KEY PLAN for Phase I – Final Proposed Project Master Plan, October 10, 2011

ADDITIONAL DETAILED INFORMATION

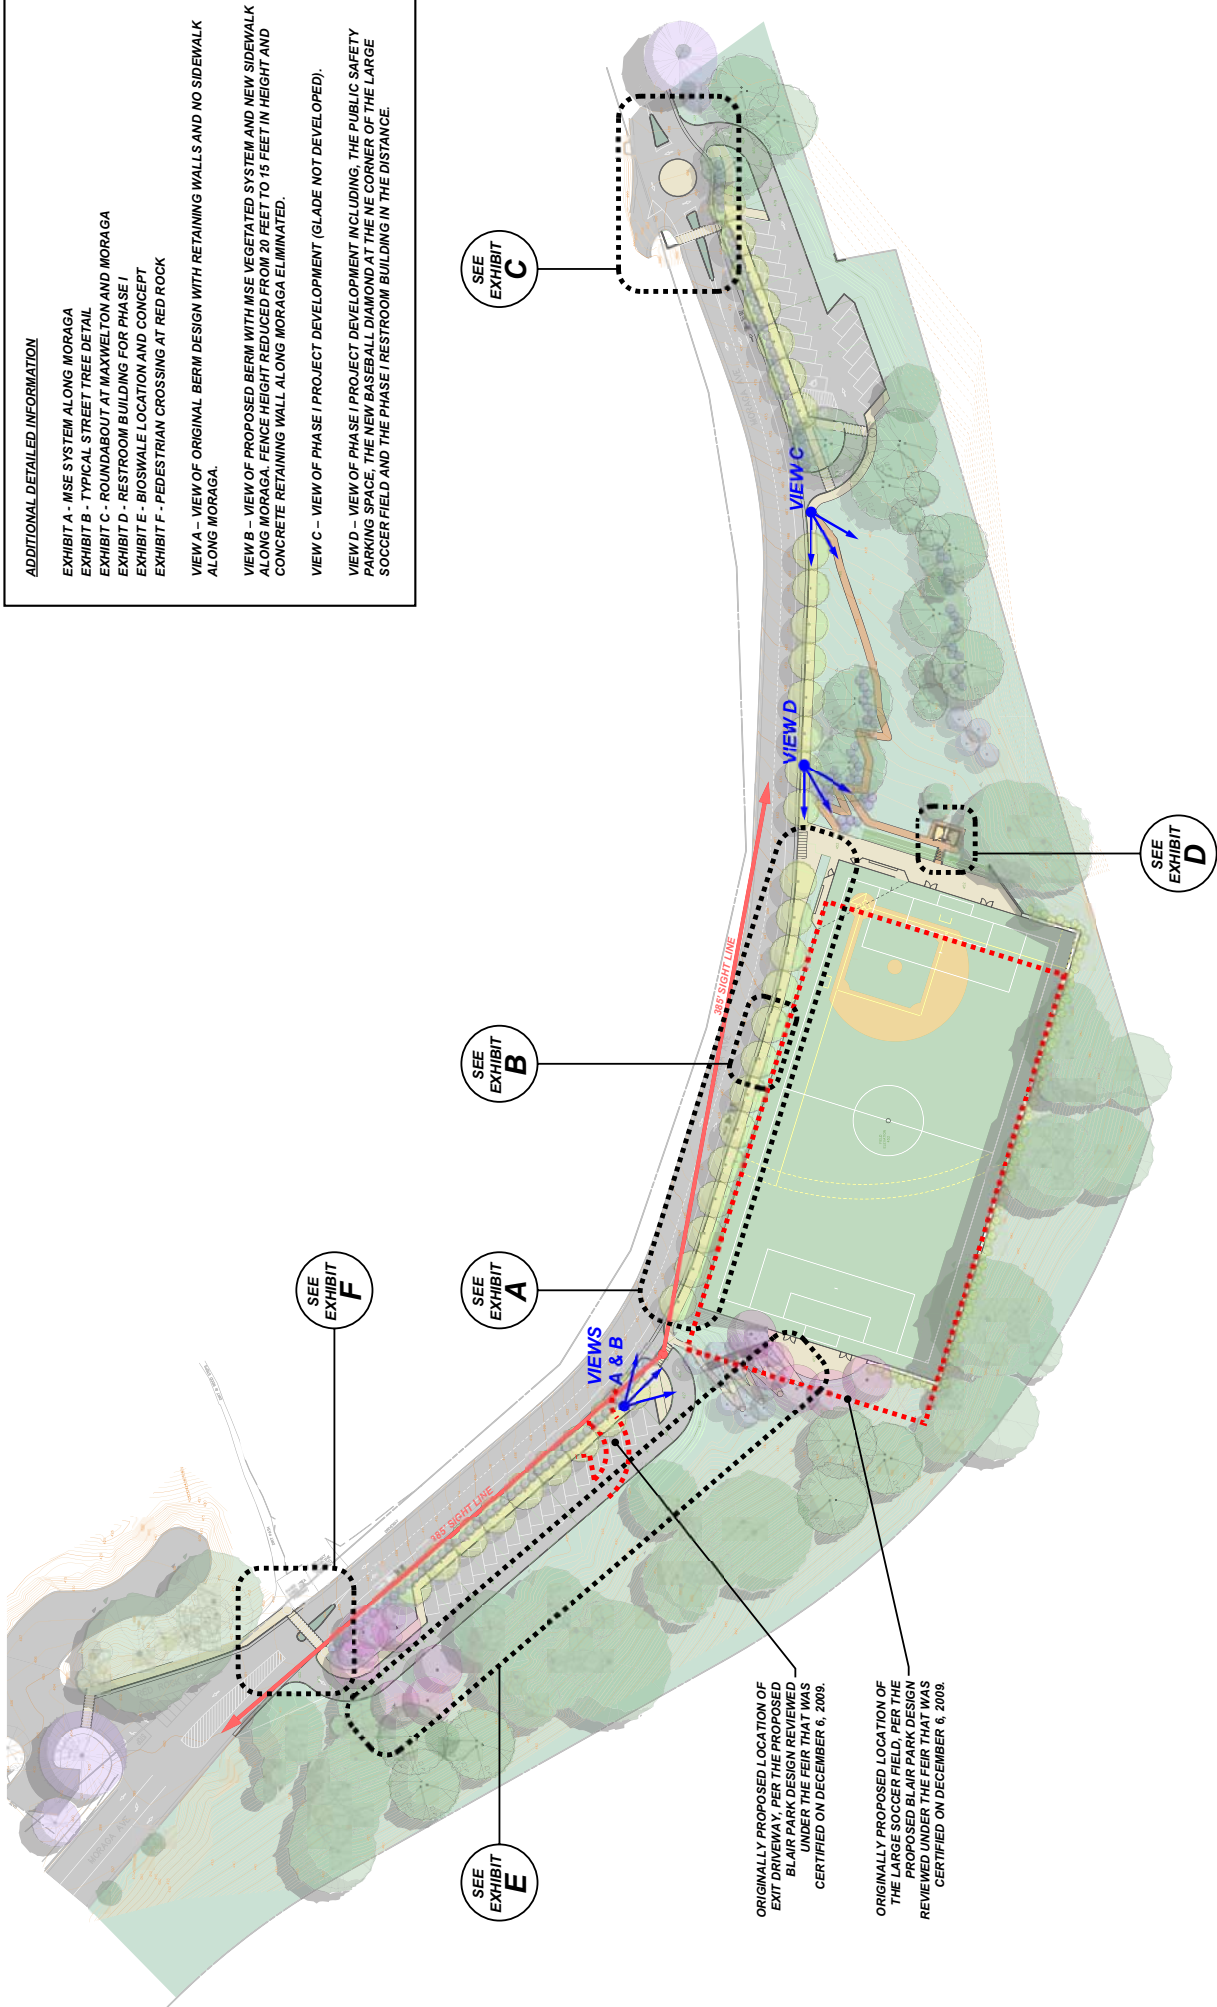
VIEW A - VIEW OF ORIGINAL BERM DESIGN WITH RETAINING WALLS AND NO SIDEWALK ALONG MORAGA.

VIEW B - VIEW OF PROPOSED BERM WITH MSE VEGETATED SYSTEM AND NEW SIDEWALK ALONG MORAGA. FENCE HEIGHT REDUCED FROM 20 FEET TO 15 FEET IN HEIGHT AND CONCRETE RETAINING WALL ALONG MORAGA ELIMINATED.

VIEW C - VIEW OF PHASE I PROJECT DEVELOPMENT (GLADE NOT DEVELOPED).

VIEW D - VIEW OF PHASE I PROJECT DEVELOPMENT INCLUDING THE PUBLIC SAFETY PARKING SPACE, THE NEW BASEBALL DIAMOND AT THE NE CORNER OF THE LARGE SOCCER FIELD AND THE PHASE I RESTROOM BUILDING IN THE DISTANCE.

ORIGINALLY PROPOSED LOCATION OF EXIT DRIVEWAY, PER THE PROPOSED BLAIR PARK DESIGN REVIEWED UNDER THE FEIR THAT WAS CERTIFIED ON DECEMBER 6, 2009.

ORIGINALLY PROPOSED LOCATION OF THE LARGE SOCCER FIELD, PER THE PROPOSED BLAIR PARK DESIGN REVIEWED UNDER THE FEIR THAT WAS CERTIFIED ON DECEMBER 6, 2009.
